Model Difference Letter

Changyou Technology (Zhejiang) Co., Ltd., is applying for FCC ID: 2BEKX-SYZ for the model: TO-Q-SY2-JZT. The PCB layout is as follows:

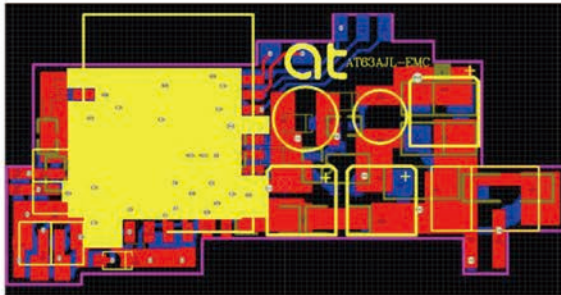
Differences: TO-Q-SY1-JZT is based on TO-Q-SY2-JZT but with the removal of the temperature sensing resistor (100K ohm NTC).

All other electrical principles, performance, functions, and key components used internally are the same. These differences will not affect the qualified assessment of electromagnetic compatibility and safety regulation tests.
